CORRECTIONS/AMENDMENTS TO THE DRAWINGS

REMARKS

Corrected Drawings - Annotated

Figure 2A

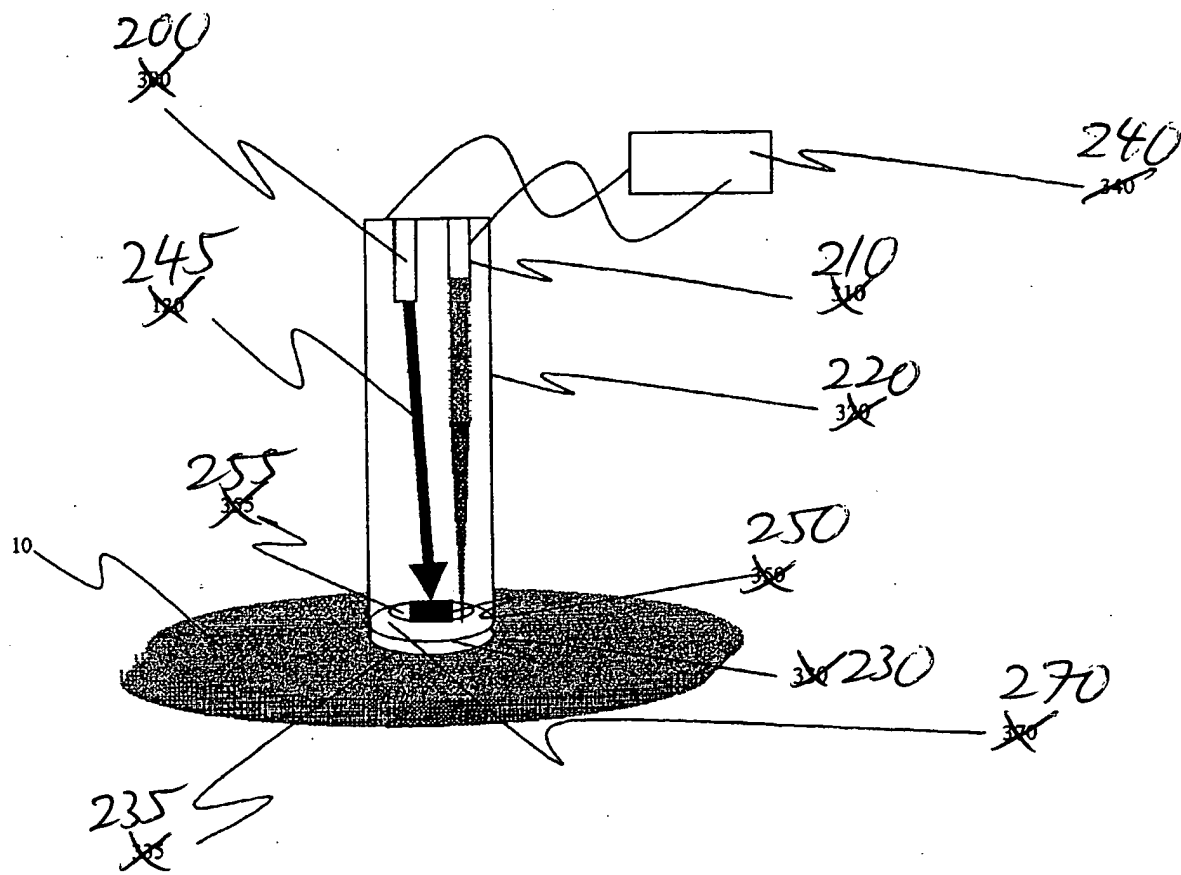
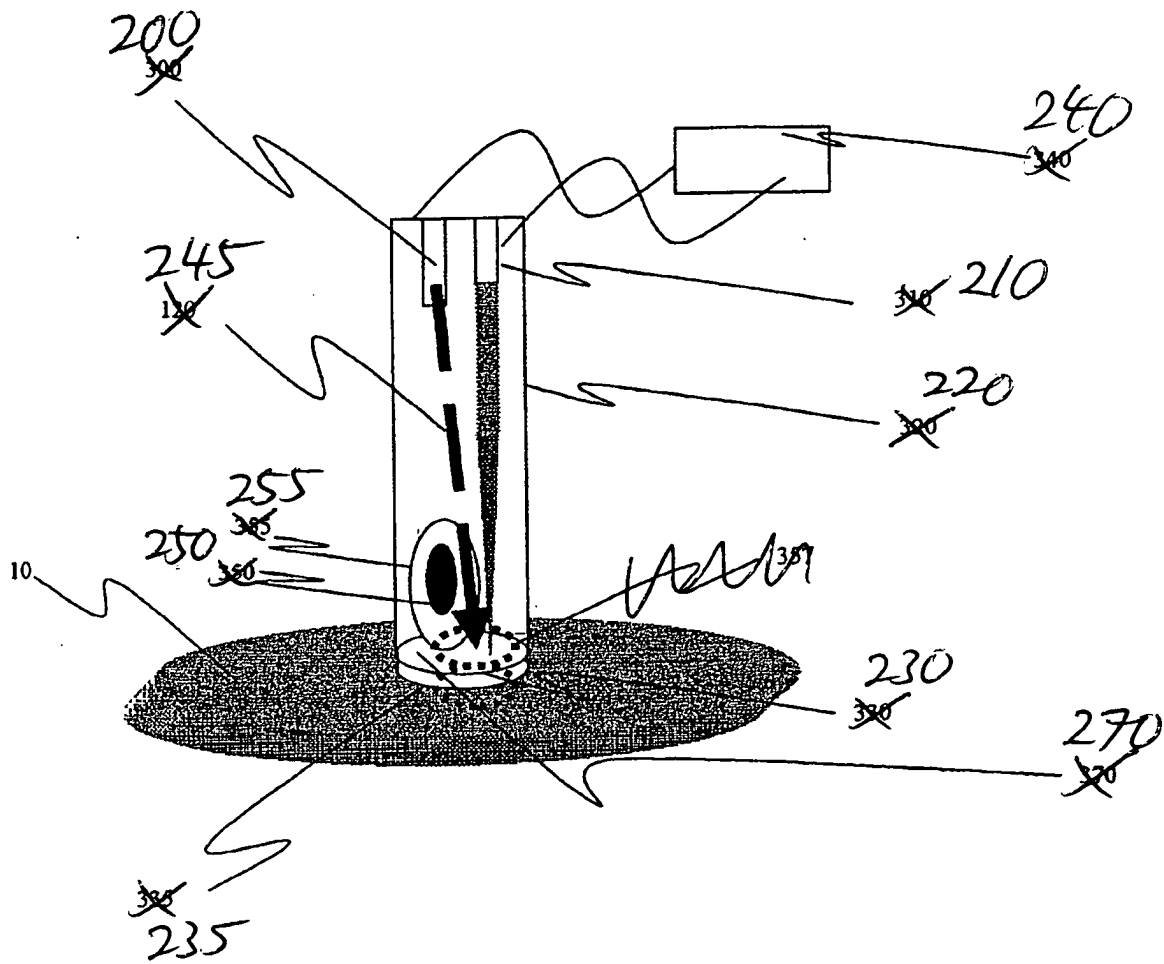
Regarding the device “sized and configured to be held in the hand,” Applicant notes that the specification refers to various handpieces, which are also depicted in the drawings, including a cylindrical handpiece (e.g., Figs. 2A – 2B) as well as a pistol-shaped handpiece (Fig. 4), and the application is thus believed to depict and describe devices sized and configured to be held in the hand. However, to expedite prosecution of the application, the claims have been amended to simply recite the term “handpiece,” which is taken directly from the specification.

Figure 7C ~~the broad beam.~~

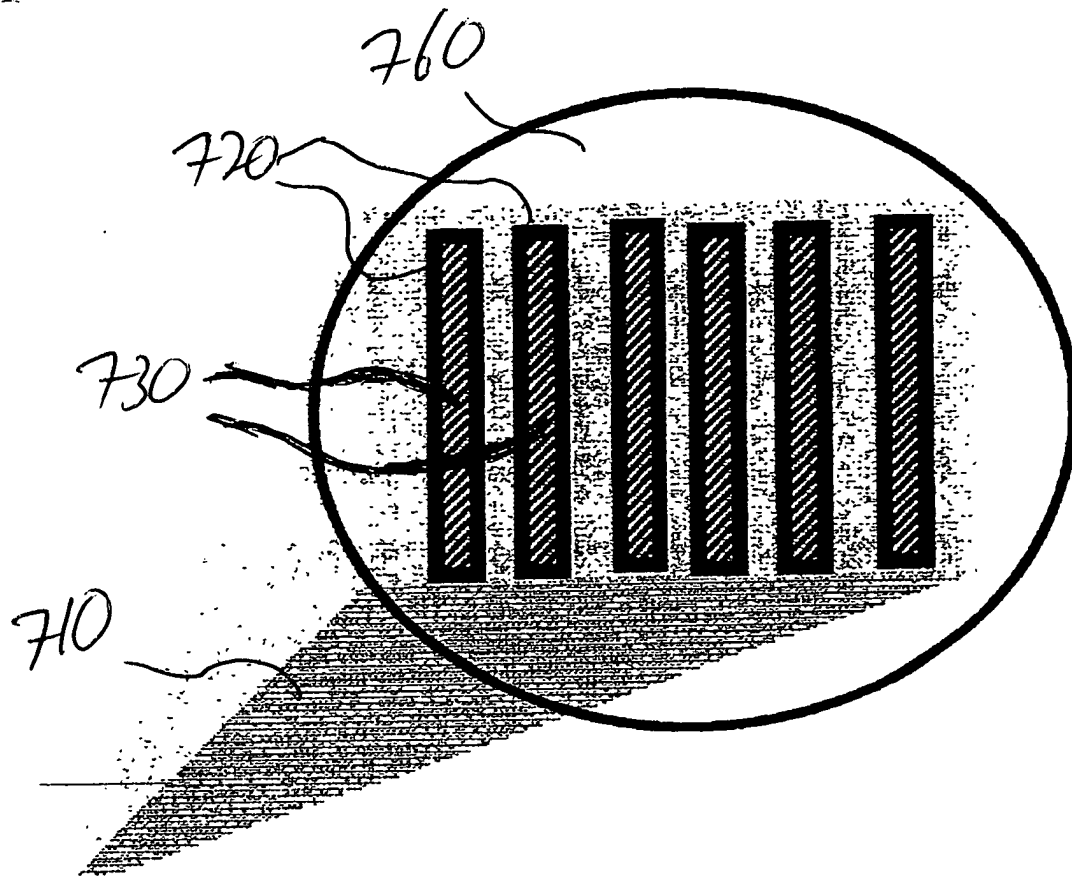
FIGS. 1A through 7F have been amended to change reference numbers for consistency with corresponding amendments to the reference numbers in the specification.

Figure 7D The disposable cup with intermediate material showing the intermediate material to be put in contact with the target material.

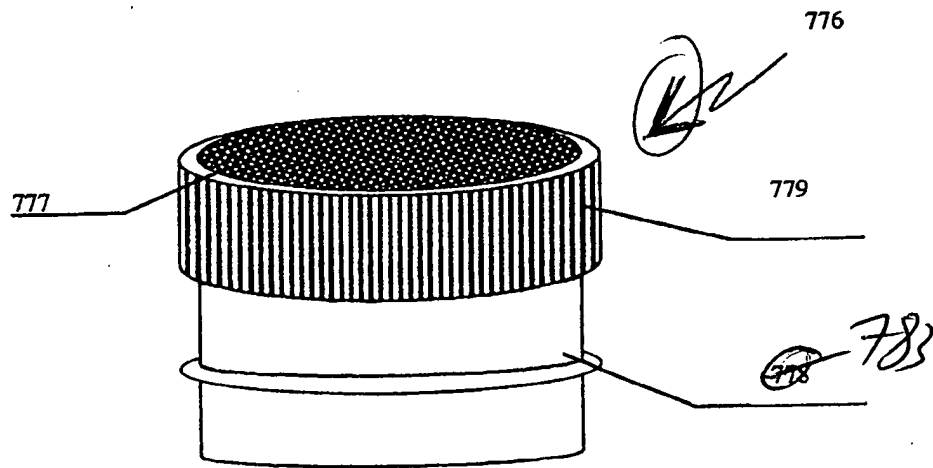
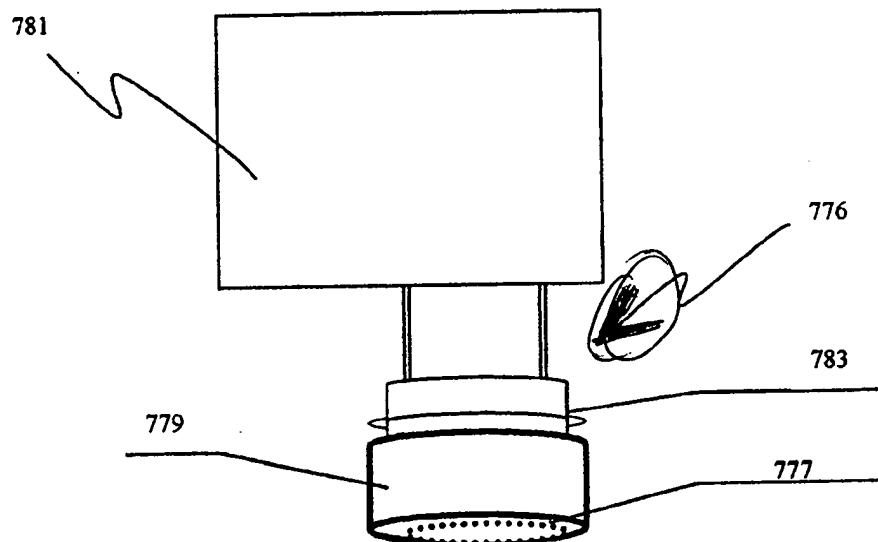
New claims 64 through 68 have been added. Claim 64 includes limitations relating to a cap, which is supported throughout the application, including in Figs. 7D – 7E. Claims 65-68 include limitations regarding the surface area of the absorbing material and of scanning said area. Support for these new claims is found throughout the application, including at paras. 0086, 00157, and 00246 of the Specification. No new matter is added by the new claims.
